# NOTIFICATION OF RESPONSE TO SUBMISSIONS Shell Cove Boat Harbour

Application No: MP 07-0027 MOD 1, Boollwaroo Parade, Shell Cove

Here are our objections to the proposed modification of Application 07-0027 Boollwarroo Parade Shell Cove, following notification of response to submissions:

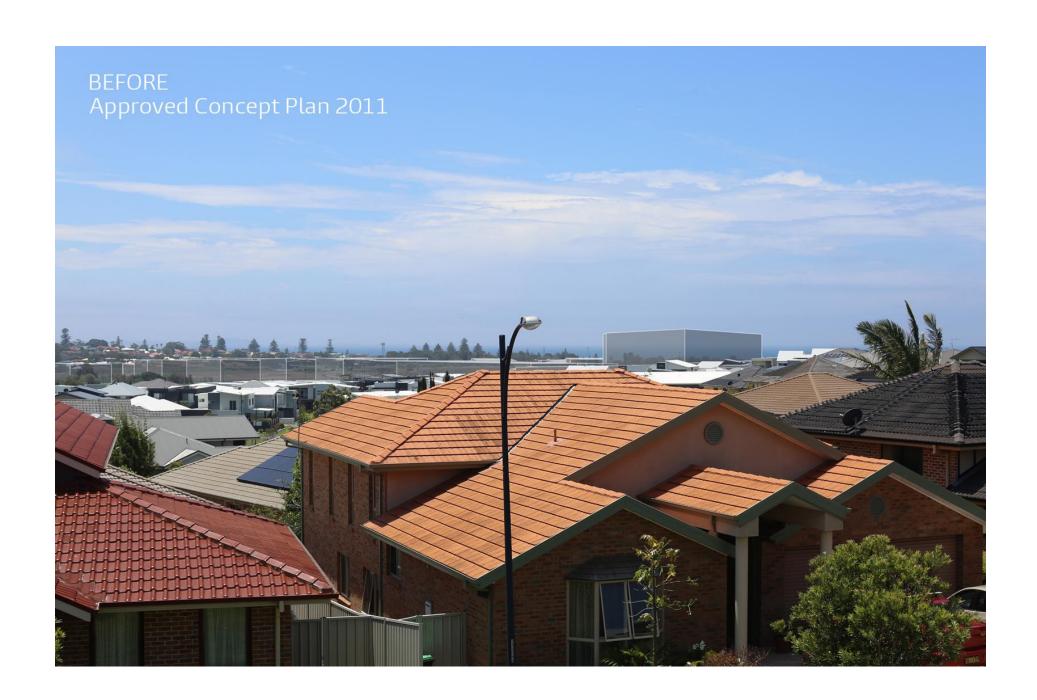
We object to the proposed relocation and increase in height of the modified Hotel, (from 8 to 11 storeys). In the Approved Concept Plan 2011 the proposed Hotel blocked our view of the ocean and horizon off to east north east side of our property. However, in the Proposed Modified Concept Plan 2017 the Hotel has been moved to a more significant position immediately in front of our home, completely blocking the view of 2 of the 13 tall Norfolk Island Pines, sections of the Pacific Ocean between Shellharbour and Big Island, (off Port Kembla), as well as Big Island itself. This new location of the Hotel will have a major impact on the northerly views directly in front of our home from our first floor balcony. One of the major reasons we purchased our property was because of the ocean views to the north. The proposed modified Hotel will be a significant 'Eyesore' immediately in front of our home, and will greatly reduce the value of our property. (See attached photos).

We object to the proposed increase in height of the Apartment and Residential Buildings, (up to 6 storeys). Residential apartments and homes in the Marina Precinct are currently approved for heights of between 2 and 4 storeys. At these heights, there was no negative visual impacts on our views from our home. The modified increases in heights of 4 to 6 storeys will have an extreme negative impact on our view to the north, blocking out sections of Shellharbour Village, the lower half of 4 large Norfolk Island Pines, the ocean water between Warilla and Red Point, as well as the golden sands of Windang/Perkins Beach, (in the Port Kembla area). The proposed increase in height of the Apartments and Residential Buildings will block and destroy picturesque ocean and beach views currently seen from our front balcony, as well as greatly reduce the value of our property. (See attached photos).

- 2. 'The proposed increased height will not create significant changes to the composition of views, relative to the Concept Approval built form'. The increase in height, particularly for the Apartments and Residential Buildings, does create significant change to the composition of views from our front balcony. Whereas the heights in the Approved Concept Plan had no visual impact on our coastal views, the Proposed Modified Concept Plan cuts out half our view of Shellharbour Village, cuts through the middle of 4 large Norfolk Island Pines and a huge Fig Tree, and completely removes our view of the golden sands of Perkins Beach and the ocean at Port Kembla.

There is a significant quantitative increase in view loss from our home, of the ocean in front of Perkins Beach. In fact the full length of the beach sands and the ocean water at Perkins beach will be cut off due to the height increase of the Apartments and Residential Buildings. Also, the overall composition of the Concept Approval and Modification are not qualitatively similar. The visual impact due to the increased height and re-orientation of the Hotel to an E-W alignment will be a major eyesore for residential homes to the south of the Marina site. A number residential homes along Mystics Drive have front balconies facing north, with the proposed new Hotel location immediately in front of them.
